Communication from the City Plan and Zoning Commission advising that at their meeting held April 4, 2013, the following action was taken regarding a request from Hy-Vee, Inc. (lessee) represented by John Brehm (officer) to amend the Southgate C-4 Development Plan for property at 3221 Southeast 14<sup>th</sup> Street.

RE: 3215 SE 14<sup>th</sup> Street, Hy-Vee Convenience Store  
10-13-7.89

We have reviewed the first (1st) submittal of the site plan for the Hy-Vee Convenience Store SE 14<sup>th</sup> Street, located at 3215 SE 14th Street in Des Moines, and have determined that the following conditions must be satisfied before plan approval can be granted.

**UTILITY PLAN**

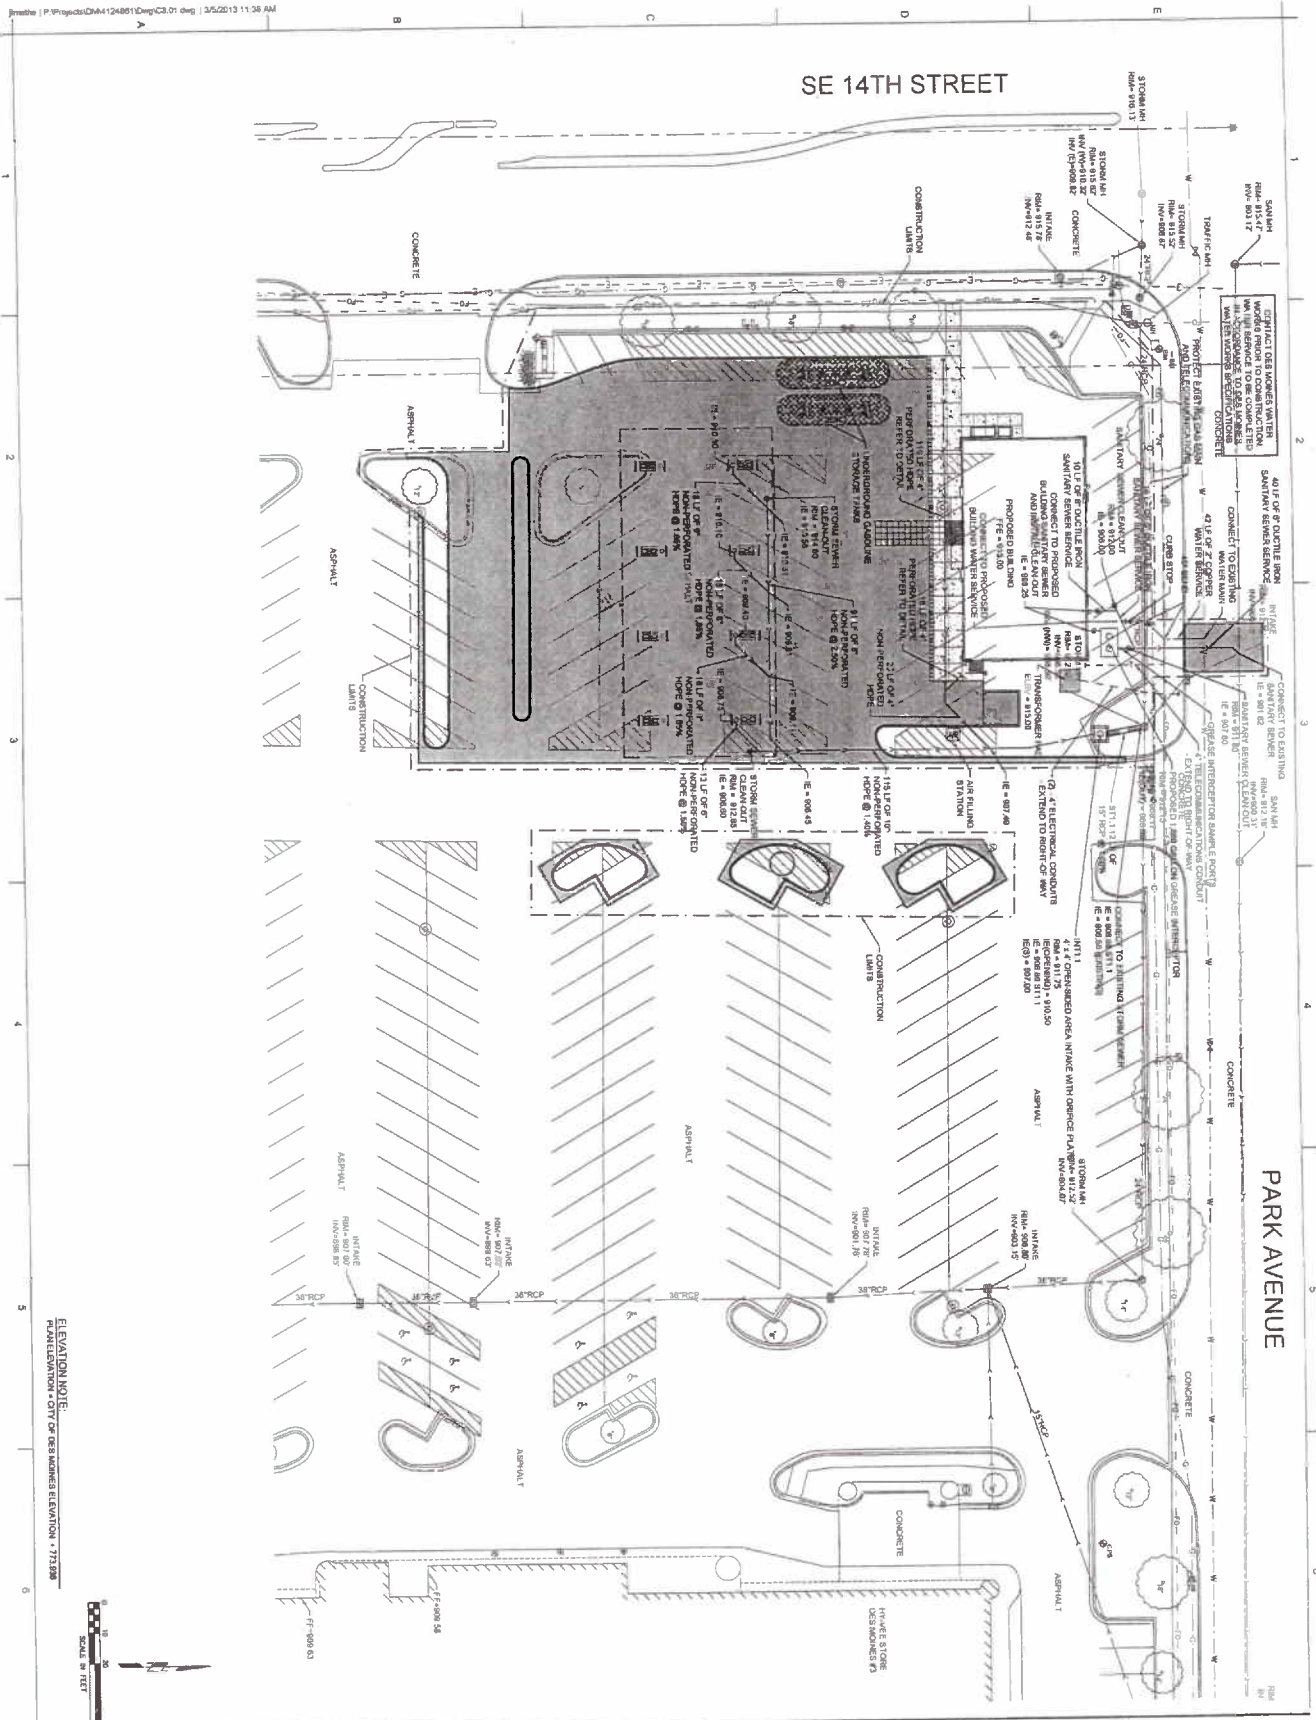
1. Show and identify the roof drainage outlet locations on the proposed building.
2. Show the size of the existing public sanitary sewer in E. Park Avenue.
3. Show and properly locate the existing public storm sewer easement at the north end of the site.
4. The proposed HDPE storm sewer pipe material from the canopy to the proposed area intake as well as from under the sidewalk will most likely not meet Plumbing Code. These pipes do not have to meet Plumbing Code if they can outlet to daylight in the basin since this would not be a direct connection to our public storm sewer system.
5. The 15-inch RCP storm sewer exiting the proposed area intake seems to be a bit oversized.
6. The certification statement on the storm water management plan must be signed and dated.
7. Reference the orifice plate detail from Sheet C5.01 on Sheet C3.01 by the INT1.1 flag note.

OPEN-SIDED AREA INTAKE

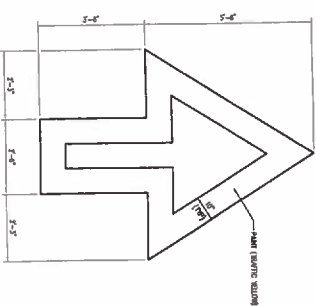
8. Detail 8/C5.02 appears to be mislabeled "OPEN-SIDED AREA INTAKE".
